STRACHAN EXPLORATION  
 4-3 BAILEY #1-18  
 NWNW SEC 3-26S-45W  
 PROWERS CO  
 API 05-099-06876-00  
 BARREL SPRINGS FIELD.

CURRENT CONDITION  
 3 SEPT 19 - SDR.

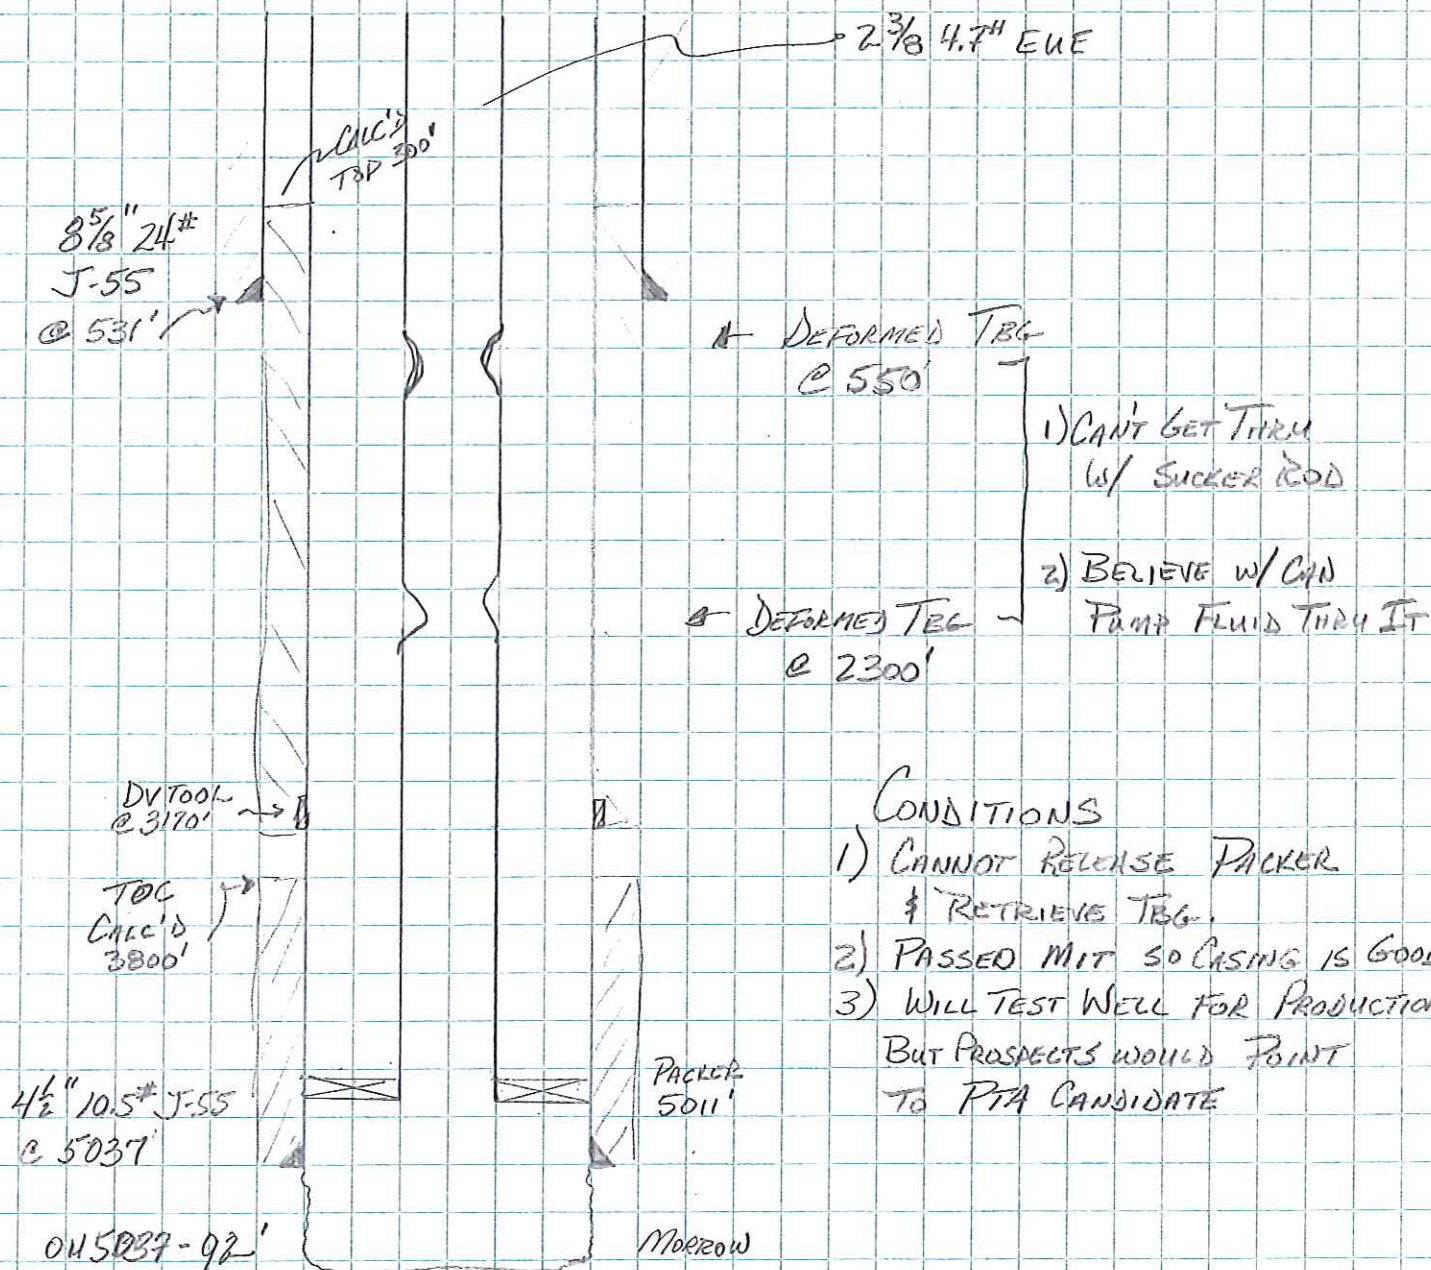
- CONDITIONS
- 1) CANNOT RELEASE PACKER  
 & RETRIEVE TBG.
  - 2) PASSED MIT SO CASING IS GOOD.
  - 3) WILL TEST WELL FOR PRODUCTION  
 BUT PROSPECTS WOULD POINT  
 TO PTA CANDIDATE

PTA QUESTION #1 - WILL WE NEED TO FISH TBG TO BELOW 550'?

#2 " " 2300'?

ANSWERED VIA EMAIL W/ D. STRACHAN 8/21/19.  
 SEE ATTACHED PLAN.

BARREL SPRINGS FIELD.

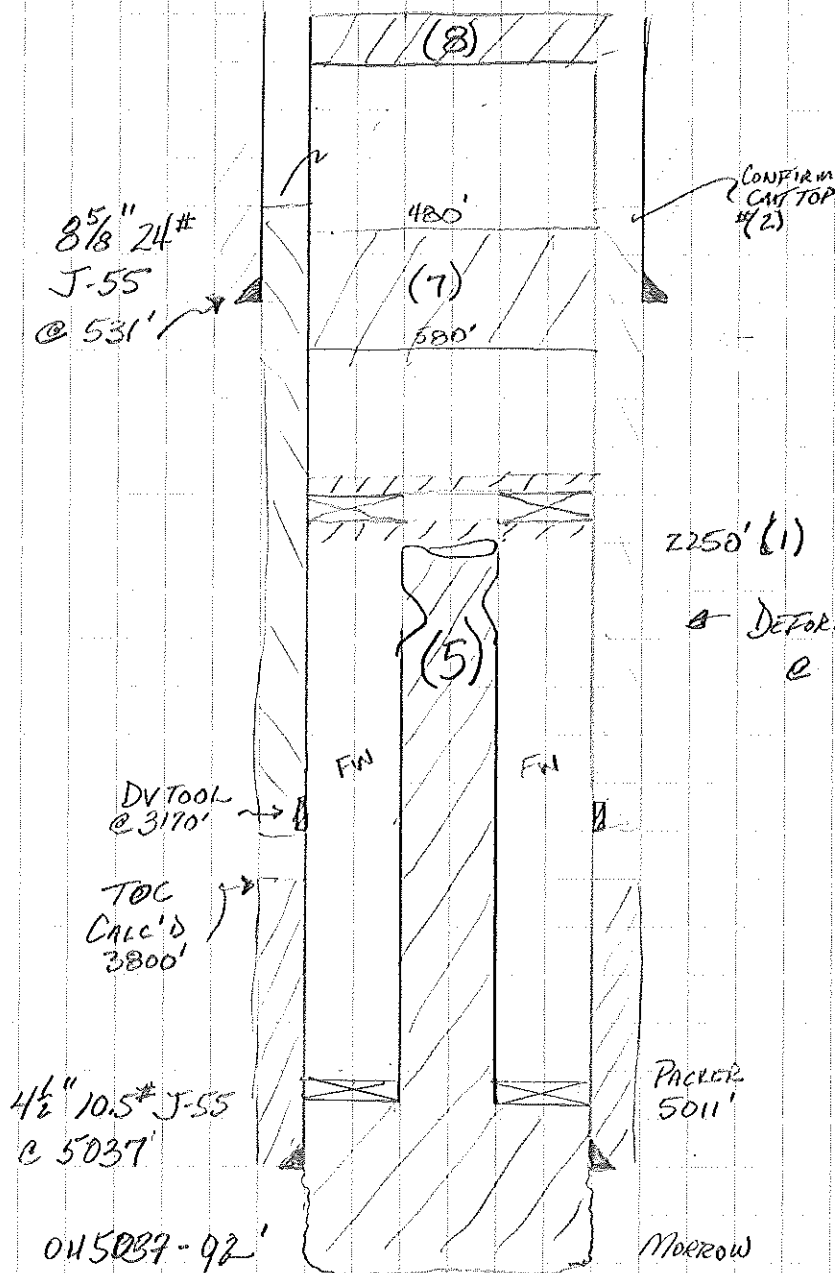
- 1) CAN'T GET THEM  
W/ SUCKER ROD
- 2) BELIEVE W/ CAN  
PUMP FLUID THRU IT

- 1) CANNOT RELEASE PACKER  
\$ RETRIEVE TEG.
  - 2) PASSED MIT SO CASING IS GOOD.
  - 3) WILL TEST WELL FOR PRODUCTION
- BUT PROSPECTS WOULD POINT  
TO PTA CANDIDATE

- 1) FISH TBLG & CUT AT ± 2225'
  - 2) RUN CBL TO CONFIRM 2ND STG  
CEMENT TOP - FOUND ABOVE SURF SURF
  - 3) SET REMAINDER #1 @ 2225'
  - 4) LOAD HOLE w/ 15 BBL FW
  - 5) PUMP 90 SK C/L CUT @ 15.6 <sup>#/g</sup> 1.15 <sup>14.3</sup>/<sub>SK</sub>
  - 6) SET 10 SK PLUG 580-470'
  - 7) SET 15 SK PLUG @ SURFACE
  - 8) CUT CSG, WELD PER SPECS.
- PER SUTPHIN EMAIL/SOR
